JAMES CITY COUNTY WETLANDS BOARD
August 8, 2007 - 7:00 PM

1. W-16-07/VMRC 07-1035: Jamestown 4-H Educational Center - 3751 4-H Club Rd

additional
SECTION
7-20-07

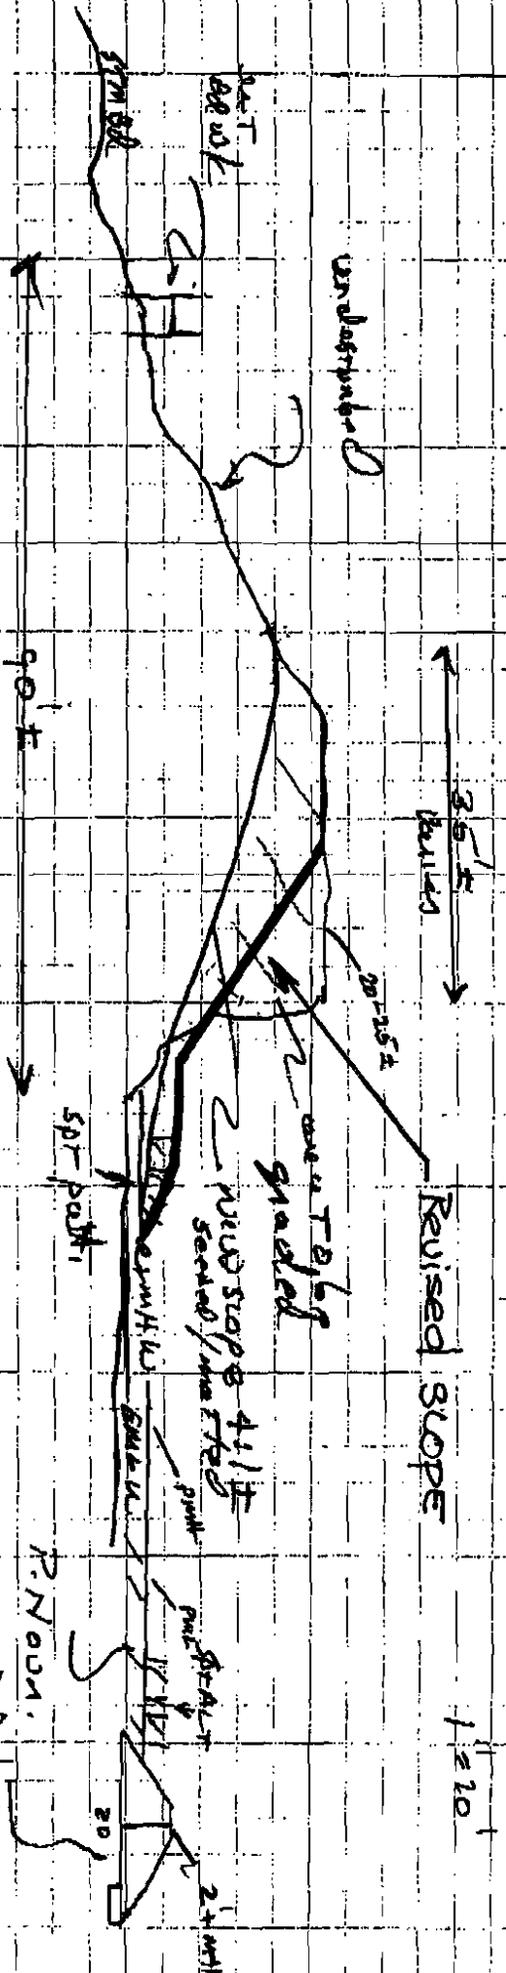
The proposed upland slope grading of the RPA buffer is of significant concern to staff and to the VIMS representative. Staff believes that the disturbance to the RPA buffer is excessive and can be significantly reduced by implementing the following changes to the application and plans:

1. Increase the top elevation of the proposed backshore sand fill dune area to + 5 above MHW and increase the beach elevation and gradient accordingly.
2. Increase the importation of sand fill from approved offsite locations requiring less onsite borrow.
3. Increase the proposed upland slope gradient to 3:1. The proposed new slope can be graded channelward at a 3:1 slope from approximate elevation + 20.0 to the top of the proposed dune at elevation +5.0. All information on the plan shall be revised to reflect the changes to the proposed grading.

Mr. Menichino stated the application proposed re-grading approximately 70 feet of the RPA buffer. He displayed a diagram of staff's recommended 3:1 slope that would reduce the impact to the buffer (copy attached). He stated this recommendation might require more fill from off-site locations.

We question the need for the proposed bank grading. If the proposed breakwater/ beach nourishment system provides adequate protection on the backshore at the base of the bank, no further action should be necessary. Additionally, there are no upland improvements at risk on landward of the bank. Removal of vegetation and destabilization of the slope should be addressed with a properly designed landscape plan that incorporates small trees, shrubs and deep-rooted grasses.

1. A revised plan shall be submitted to VMRC, VIMS, and James City County for review and approval prior to the required preconstruction meeting, which must be held on-site. The revised plan will show a reduction in the proposed disturbance to the RPA buffer that shall be limited to 30 linear feet landward from existing face of bluff.
